Our Ref: 240809.L001.MH
2 September 2024

Planning Case Officer
Planning Ref 2024/0447/01/DET

Re: Coal Authority Consultation: Battery Energy Storage Facility, Newburn, Newcastle.

TITLE
SITE LAYOUT
FOR OPERATION

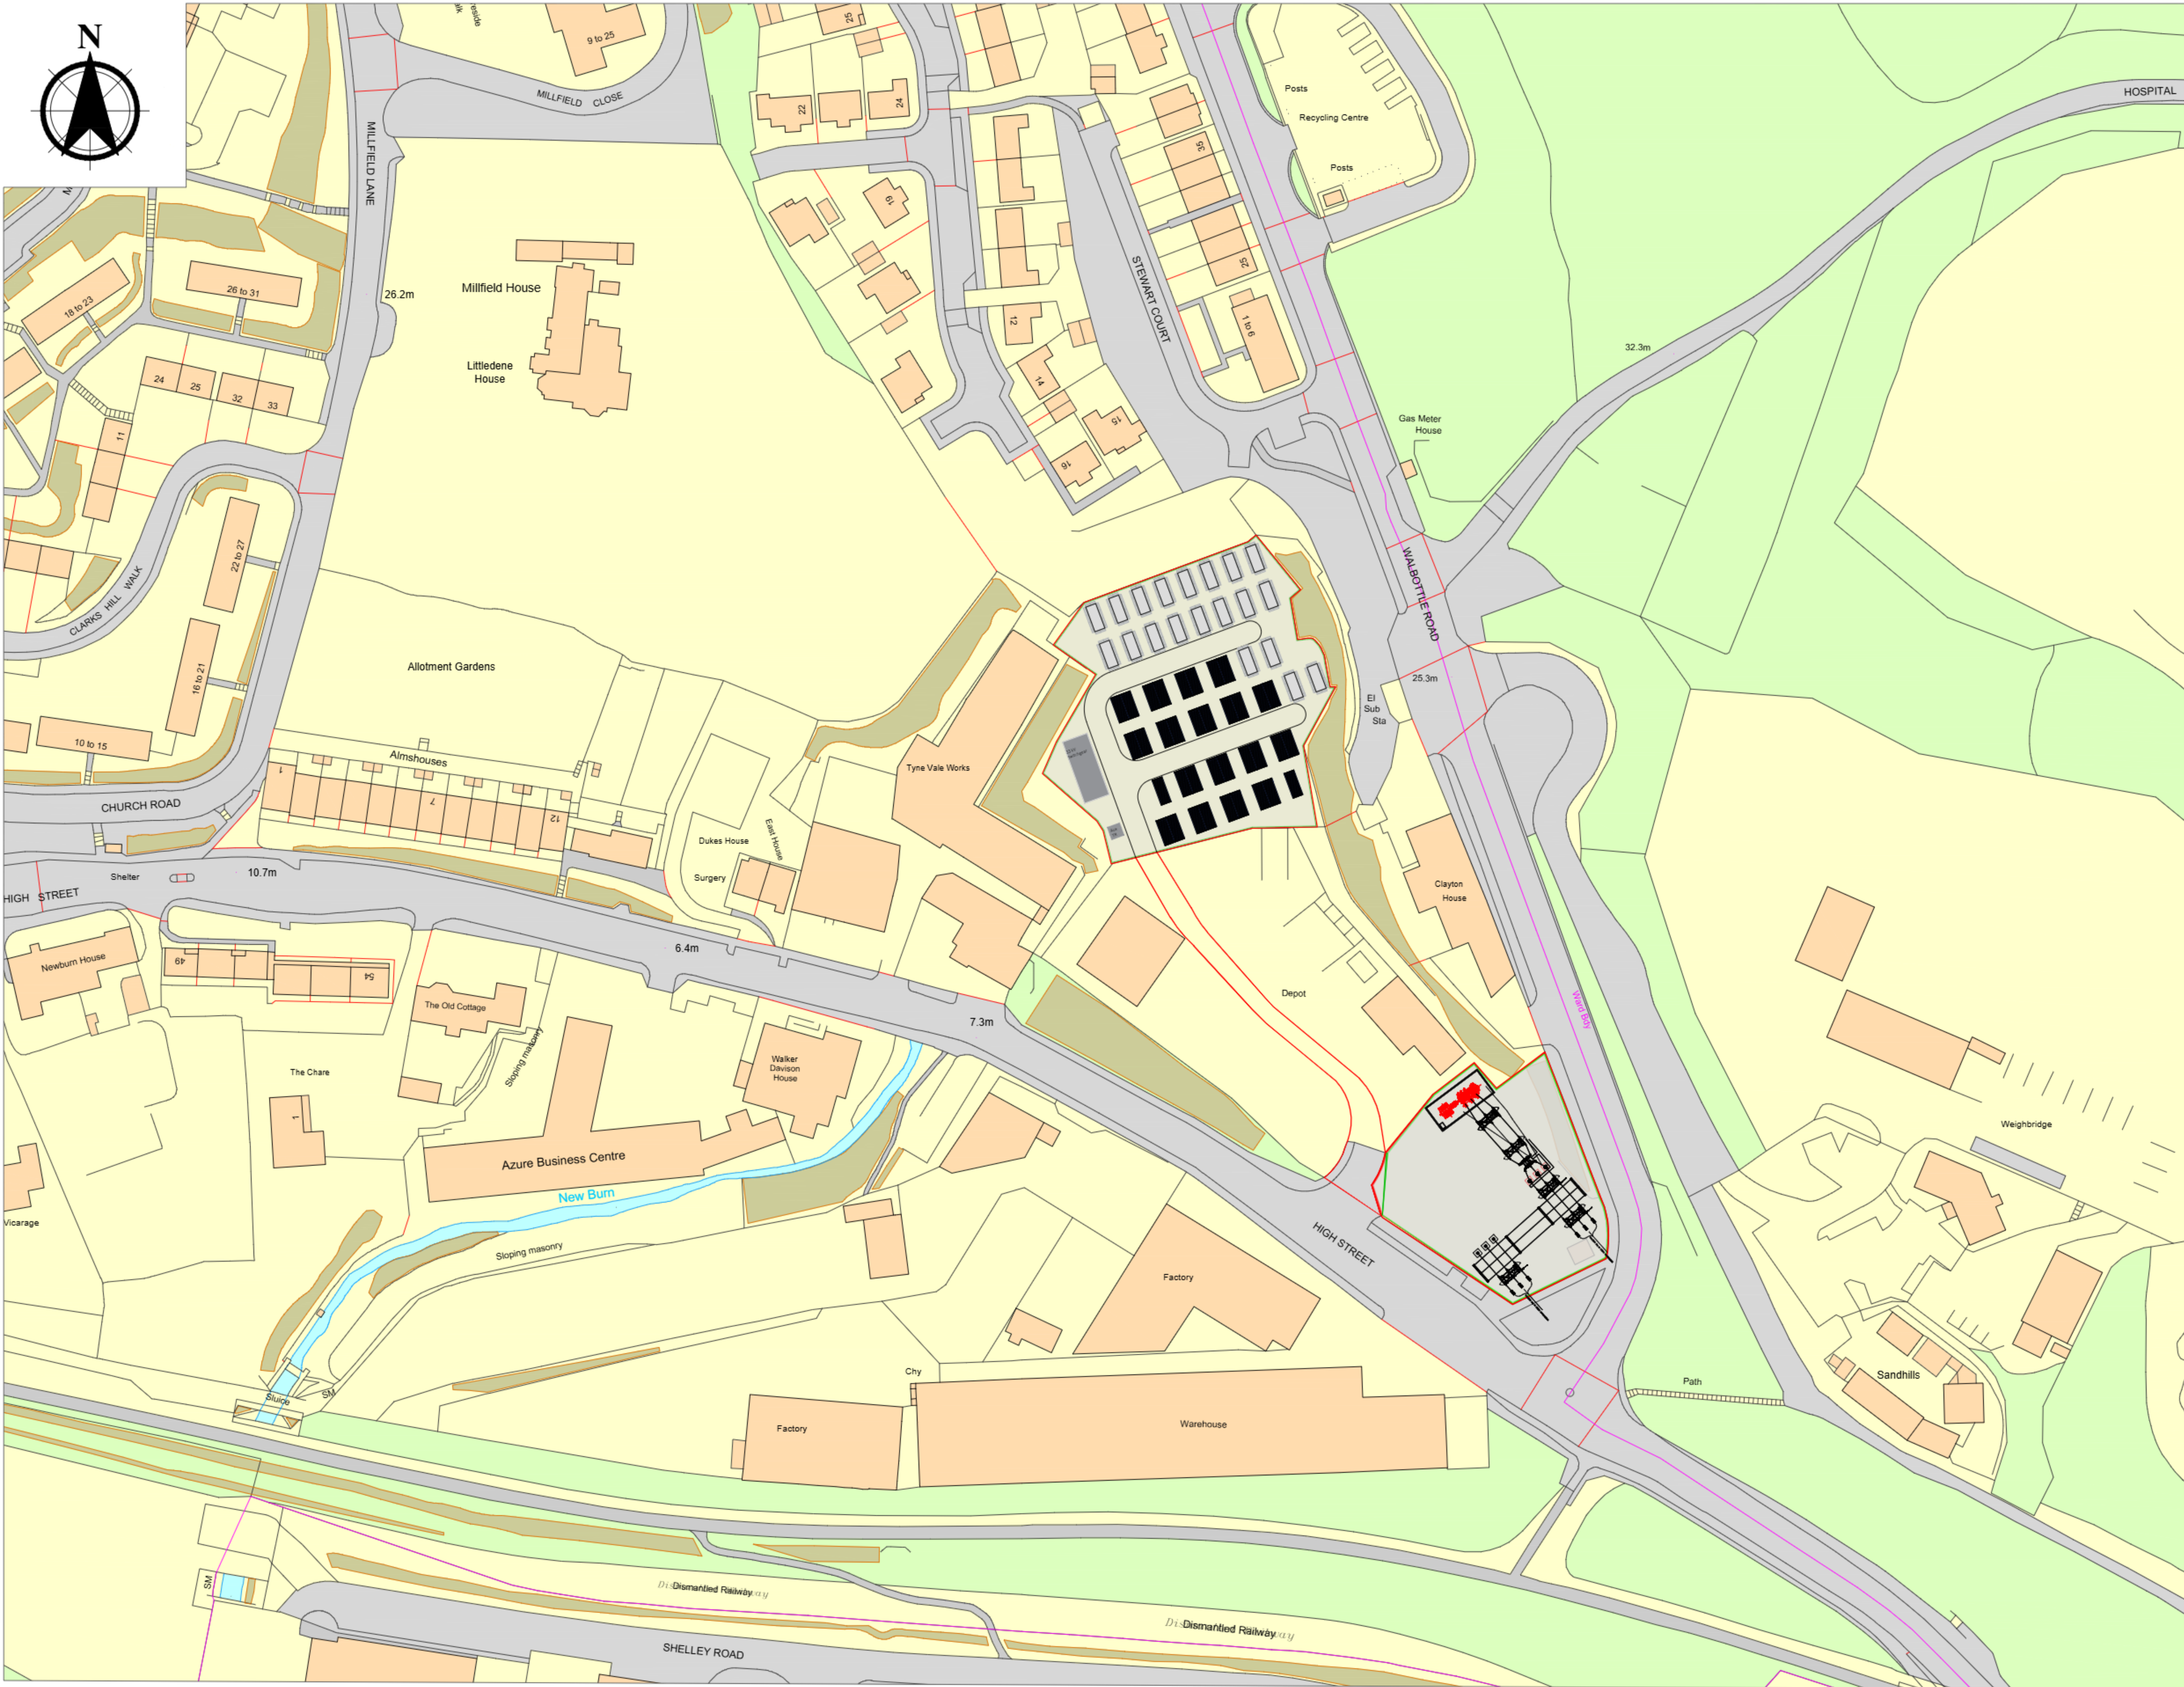
I have checked the location plan and I can confirm that the site falls within the defined Development High Risk Area. The records identify that there are numerous coal mining related risks pertaining to the application site.

The Coal Authority records indicate that the application site is likely to have been subject to historic unrecorded coal mine workings at shallow depth and that thick coal seams outcropped across the site. Voids and broken/disturbed ground associated with such workings can pose a risk of ground instability and may give rise to the emission of mine gases.

As well as the above risks, there are two recorded mine entries (shafts) that are within the immediate vicinity of the development proposals (mine entry references 417565-017 and 417565-018). The Coal Authority holds no treatment details for these mine entries and, due to plotting inaccuracies, there could be some deviation, by several metres from the inferred location. An untreated or an inadequately treated mine entry and its resultant zone of influence pose a significant risk not only to surface stability but also public safety.

Turning the situation with regard to the mine entries, the Coal Mining Risk Assessment recommends the investigation of them. However, and despite any justification being provided for potentially building directly over these coalmining hazards, the Coal Authority would expect the investigations to have been undertaken prior to the determination of the planning application, specifically to ensure the agreement of the details of any necessary remedial/mitigatory measures. The Coal Authority therefore **objects to this planning application**.

The information submitted has revealed that there is a significant risk to the development from two recorded mine entries (shafts).

Initially the applicant should be required to demonstrate the operational reasons as to as to why the proposals are required to be where they are located, or whether the layout could be amended to avoid these coal mining hazards and their respective zones of influence.

The proposed development is to comprise energy storage and distribution infrastructure with no long term/permanently occupied structures, individual components of the facility are to be placed on concrete plinths and on areas of hardstanding. Therefore, a proportion of the development is likely to include structures with minimal foundations or groundworks.

Given the lack of indoor airspace there is limited opportunity to allow the accumulation of ground gases; therefore, in the event any ground gases being produced they would likely vent to the atmosphere, which would not be considered to pose a potential risk to human health for any workers on the site or in the case of migration to off-site receptors.

Therefore, the proposed development can be considered as low sensitivity with respect to any perceived risk from historic coal mining activity.

Therefore, it is considered that a programme of on-going maintenance is considered to offer a far more pragmatic and sustainable use of resources, than a programme of drilling to identify sub-surface voids followed by grouting of shallow voids (if present).

Provided these recommendations are adopted for the site, we request that the requirement for further intrusive coal mining investigation or remedial work is removed from this planning application.
